Docket No. 50-336

Millstone Nuclear Power Station, Unit No. 2
Proposed Revisions to Technical Specifications
Pressure-Temperature Limits

January, 1984

Revise pages: 3/4 4-17
3/4 4-19b
3/4 4-20
B 3/4 4-6

Figure 3.4-2
Reactor Coolant System Pressure Temperature Limitations for 7 Full Power Years

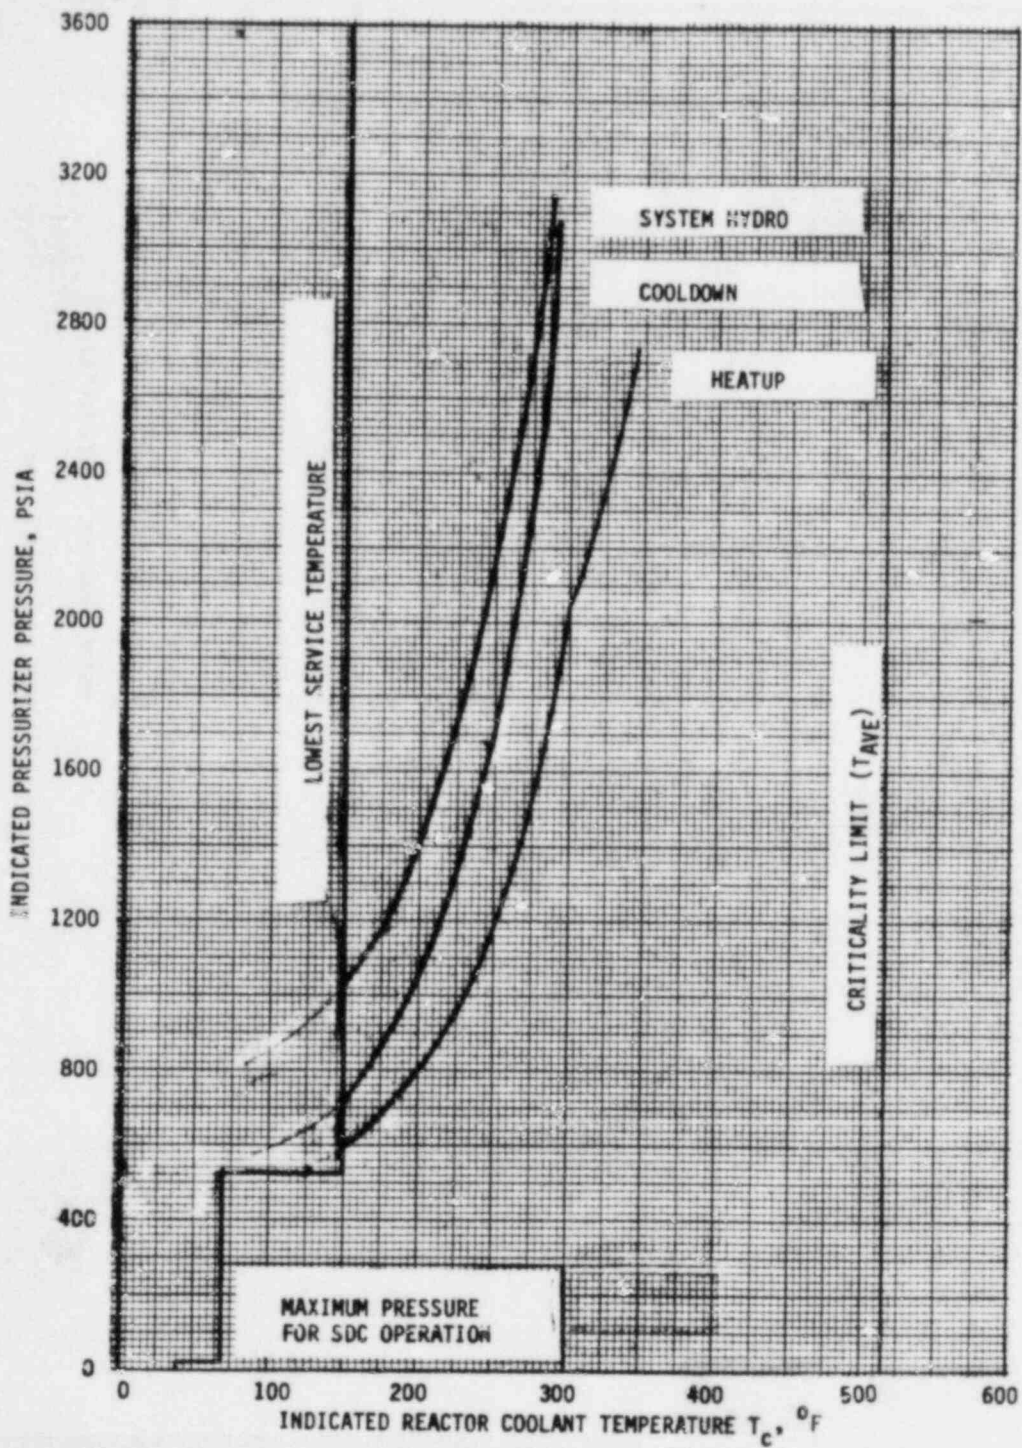
3.4.9.1 The Reactor Coolant System (except the pressurizer) temperature and pressure shall be limited in accordance with the limit lines shown on Figure 3.4-2 during heatup, cooldown, criticality, and inservice leak and hydrostatic testing with:

- a. A maximum heatup of 40°F in any one hour period with T_{avg} at or below 200°F, 50°F in any one hour period with T_{avg} at or below 300°F and above 200°F, and 100°F in any one hour period with T_{avg} above 300°F.
- b. A maximum cooldown of 100°F in any one hour period with T_{avg} above 300°F and a maximum cooldown of 20°F in any one hour period with T_{avg} below 300°F.
- c. A maximum temperature change of 5°F in any one hour period, during hydrostatic testing operations above system design pressure.

The heatup and cooldown limit curves (Figure 3.4-2) are composite curves which were prepared by determining the most conservative case, with either the inside or outside wall controlling, for any heatup or cooldown rates of up to 100°F per hour. The heatup and cooldown curves were prepared based upon the most limiting value of the predicted adjusted reference temperature at the end of the service period indicated on Figure 3.4-2.

The heatup and cooldown limit curves shown on Figure 3.4-2 include predicted adjustments for this shift in RT_{NDT} at the end of the applicable service period, as well as adjustments for possible errors in the pressure and temperature sensing instruments.
